DANE COUNTY DEPARTMENT of PUBLIC WORKS, HIGHWAY and TRANSPORTATION

RFB NO. 316042 - ADDENDUM NO. 1

STAGE 3 – GEOSYNTHETIC FINAL COVER SYSTEM

DANE COUNTY LANDFILL SITE #2

Sheet 2 - Final Grades

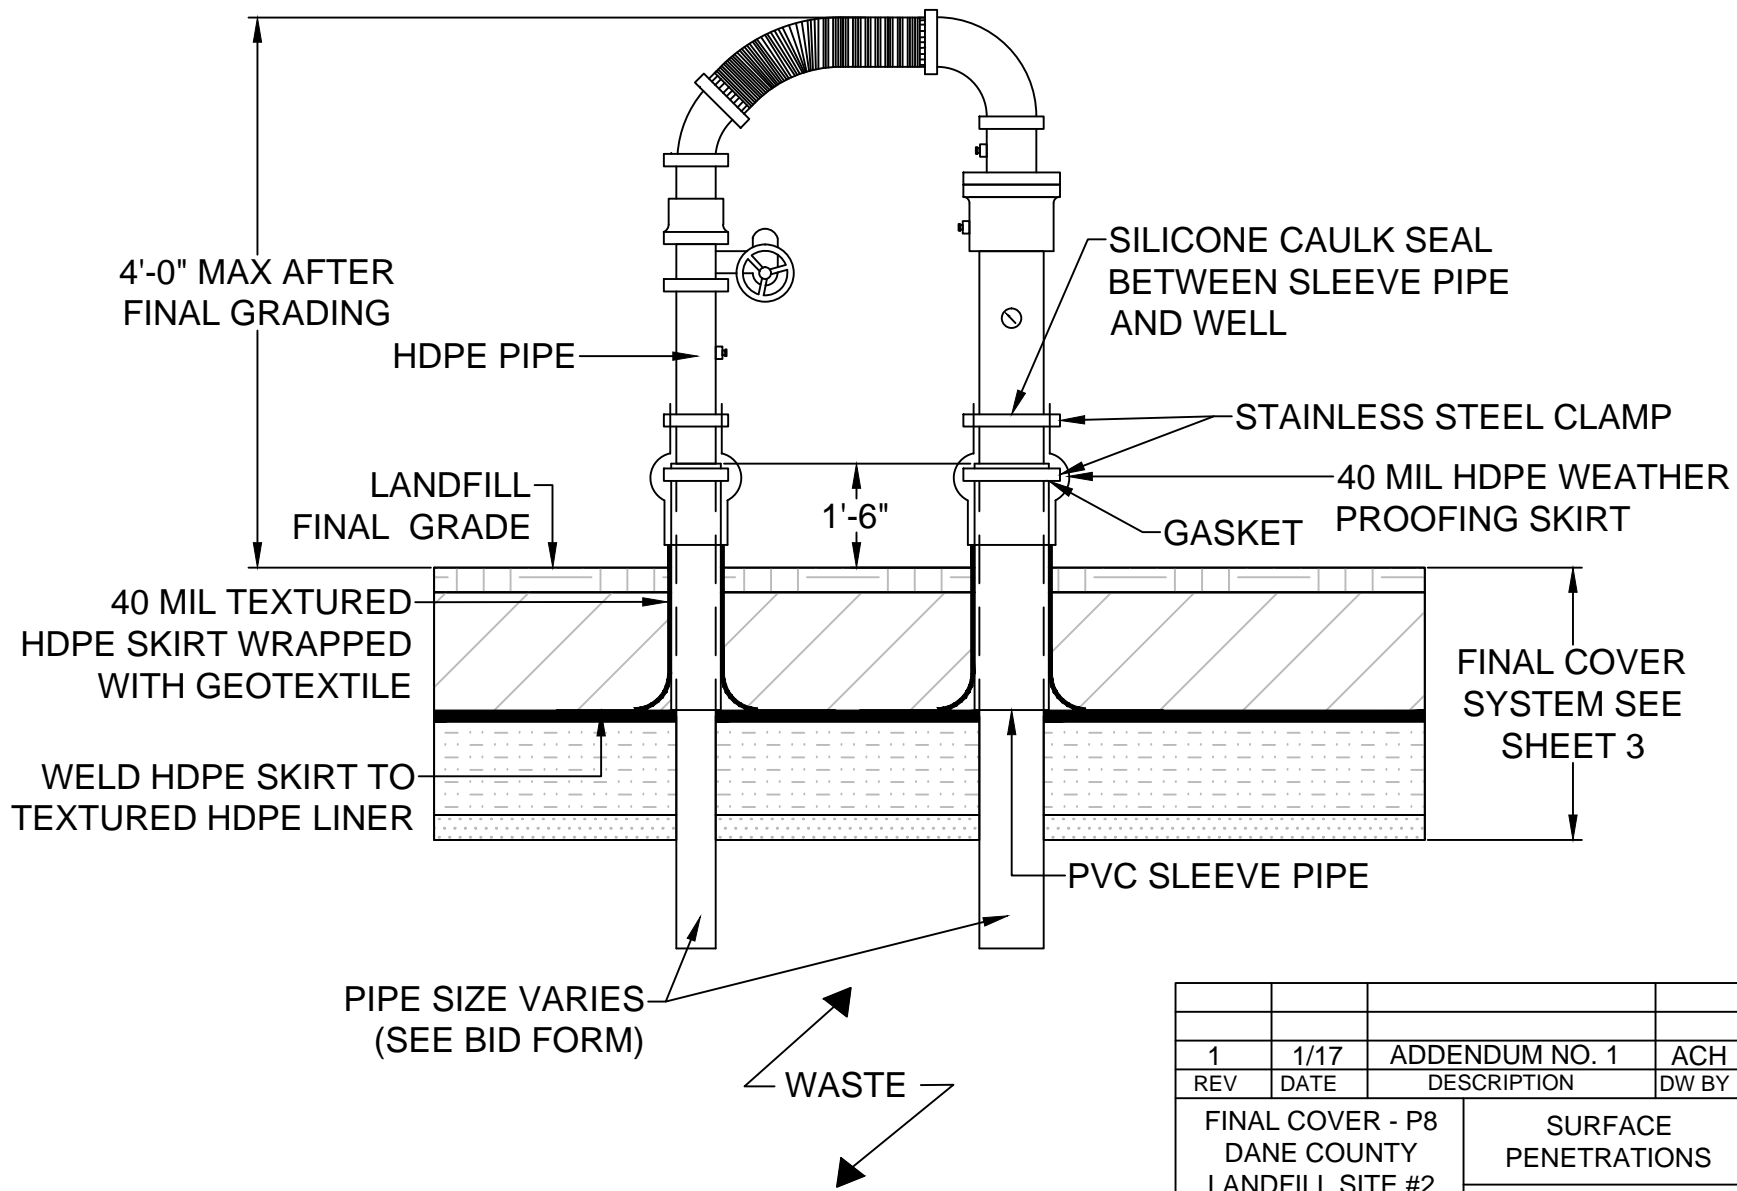
8. Sheet 2 – Final Grades

Remove Sheet 2; replace with new Sheet 2, issued with this Addendum. The revised sheet is marked “Addendum No. 1”. The new sheet has been revised as follows:

Boundaries of Work have been extended approximately 100 feet to the east, limits of waste defined, and storage locations outlined in approximate locations.

REV	DATE	DESCRIPTION	DW BY
1	1/17	ADDENDUM NO. 1	ACH
FINAL COVER - P8 DANE COUNTY LANDFILL SITE #2 7102 U.S. HIGHWAY 12 & 18		SURFACE PENETRATIONS SHEET 4 JANUARY 2017

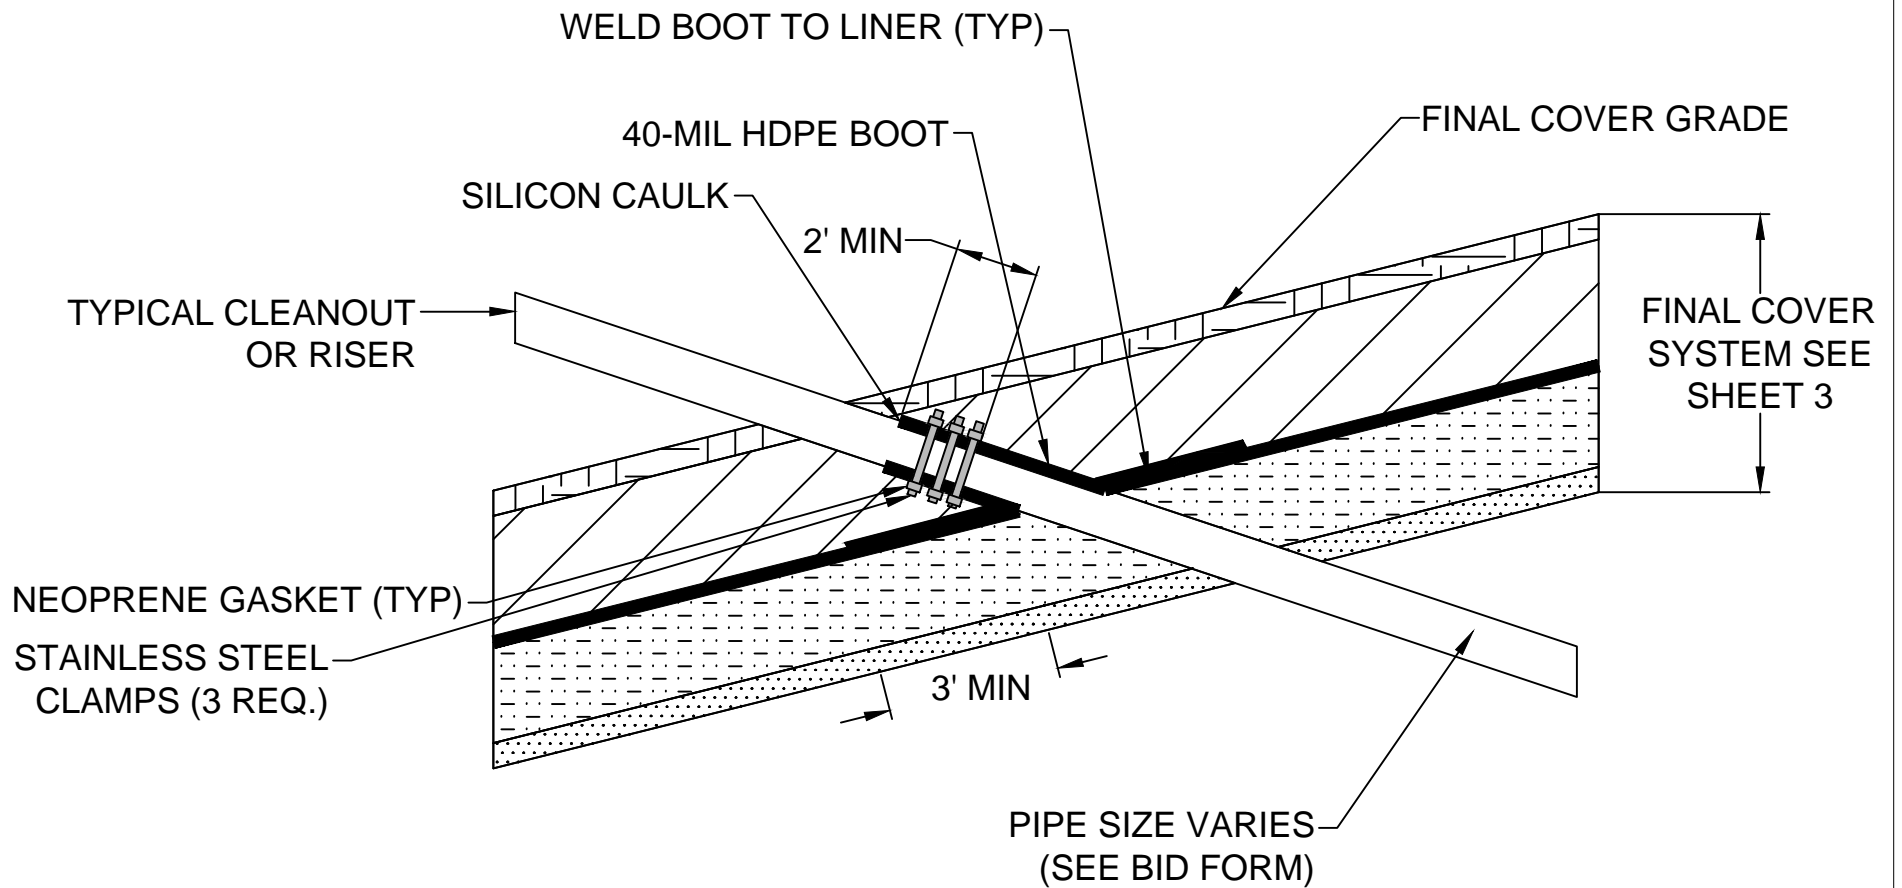
9. Sheet 4 – Surface Penetration

Remove Sheet 4; replace with new Sheet 4, issued with this Addendum. The revised sheet is marked “Addendum No. 1”. The new sheet has been revised as follows:

Note referencing pipe sizing added and changed language from “weld VLDPE skirt to textured HDPE liner” to “weld HDPE skirt to textured HDPE liner”.

REV	DATE	DESCRIPTION	DW BY
1	1/17	ADDENDUM NO. 1	ACH
FINAL COVER - P8 DANE COUNTY LANDFILL SITE #2 7102 U.S. HIGHWAY 12 & 18		SIDESLOPE PENETRATIONS SHEET 5 JANUARY 2017

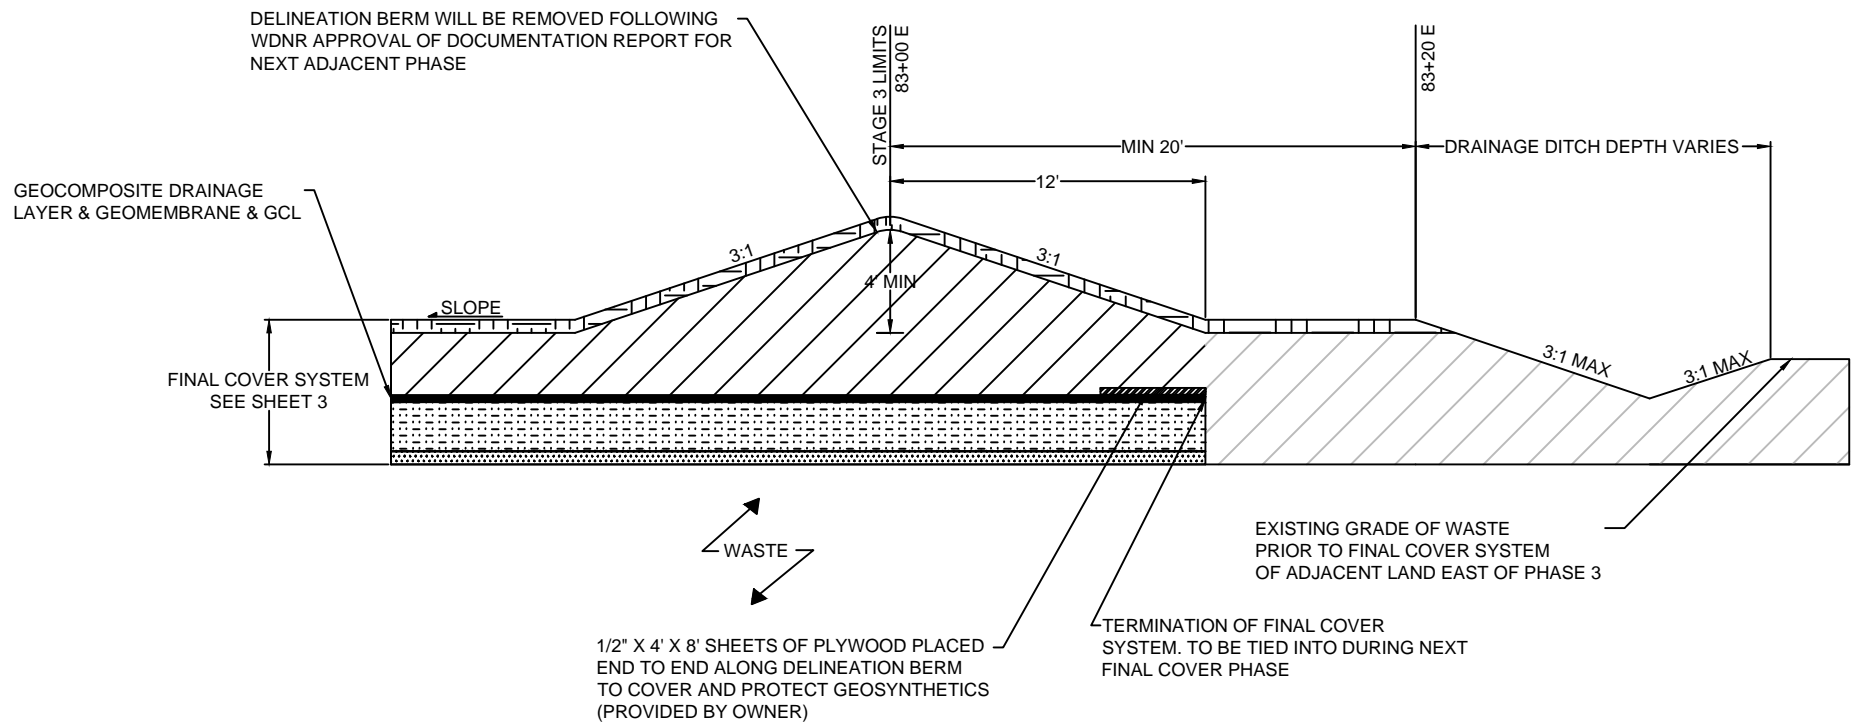
10. Sheet 5 – Sideslope Penetration

Remove Sheet 5; replace with new Sheet 5, issued with this Addendum. The revised sheet is marked “Addendum No. 1”. The new sheet has been revised as follows:

Note referencing pipe sizing added.

REV	DATE	DESCRIPTION	DW BY
1	1/17	ADDENDUM NO. 1	ACH
		FINAL COVER - P8 DANE COUNTY LANDFILL SITE #2 7102 U.S. HIGHWAY 12 & 18	PHASE DELINEATION BERM SHEET 6 JANUARY 2017

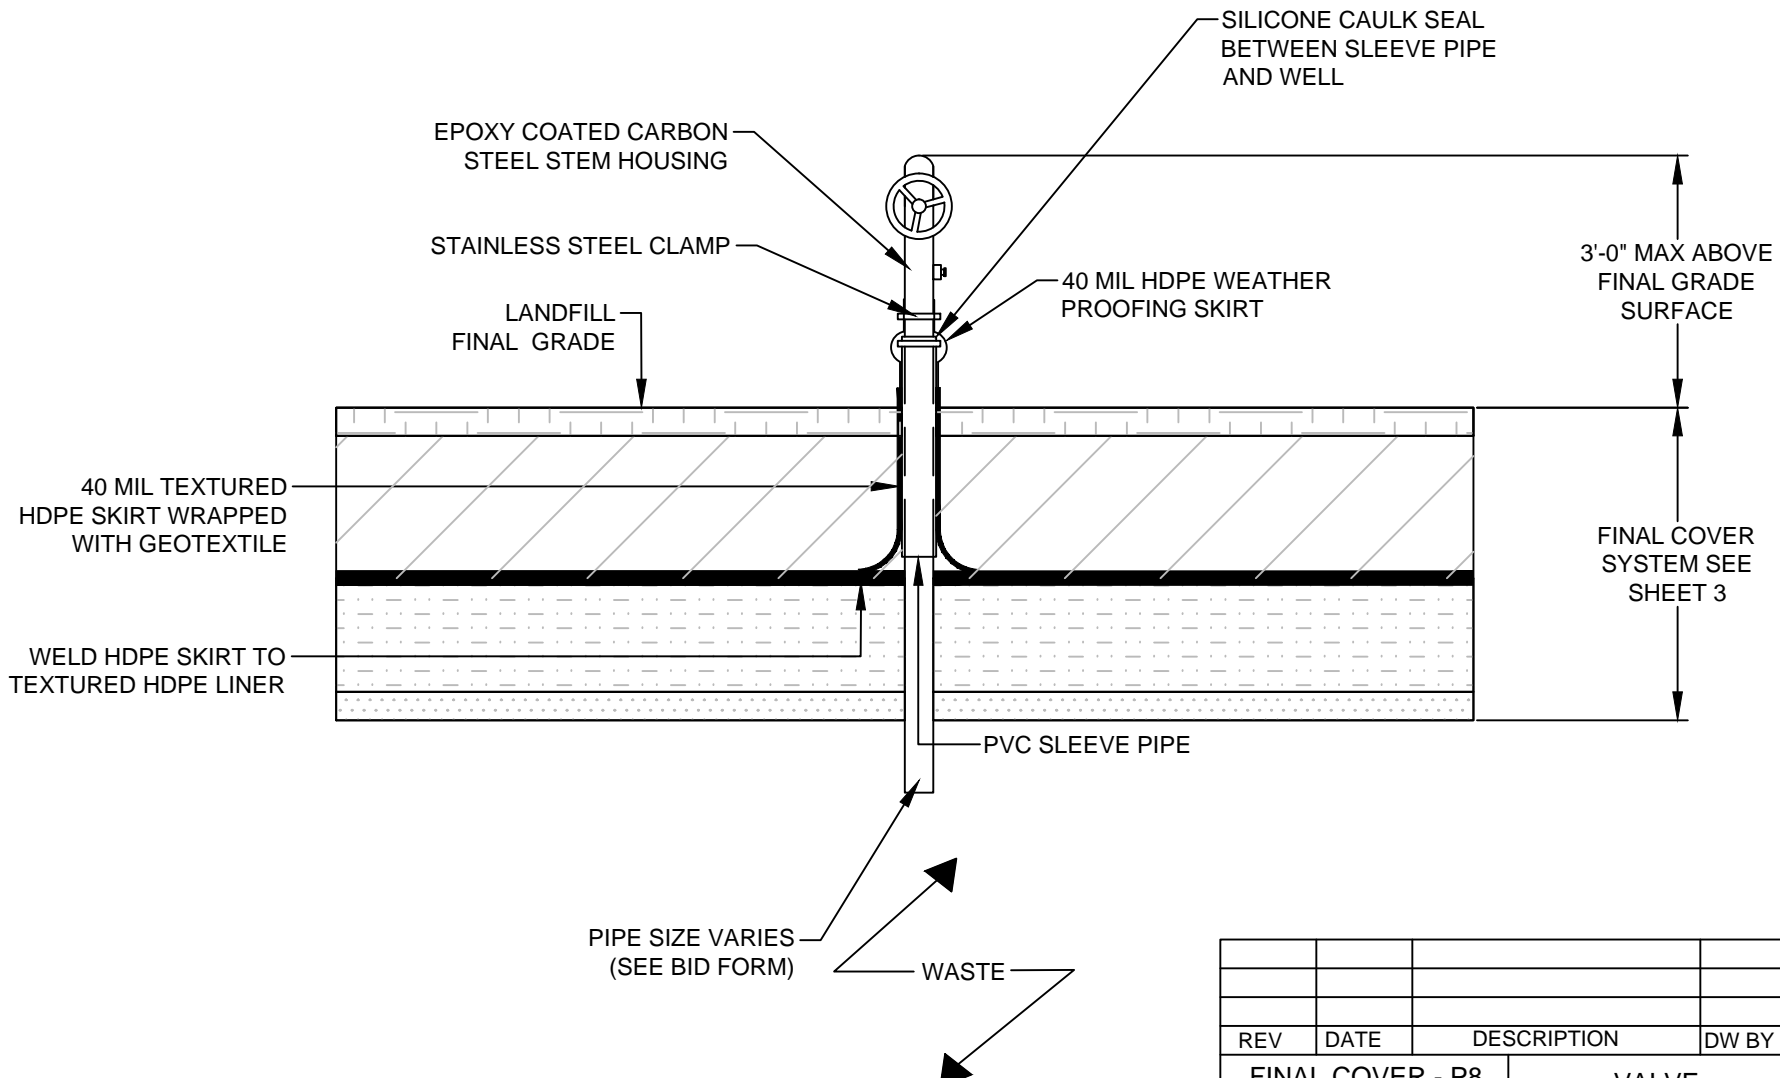
11. Sheet 6 – Delineation Berm

Remove Sheet 6; replace with new Sheet 6, issued with this Addendum. The revised sheet is marked “Addendum No. 1”. The new sheet has been revised as follows:

Revised Phase Limits to state “Stage 3 Limits” and easting coordinates revised from “82+00 E” and “82+20 E” to “83+00 E” and “83+20 E”, respectively.
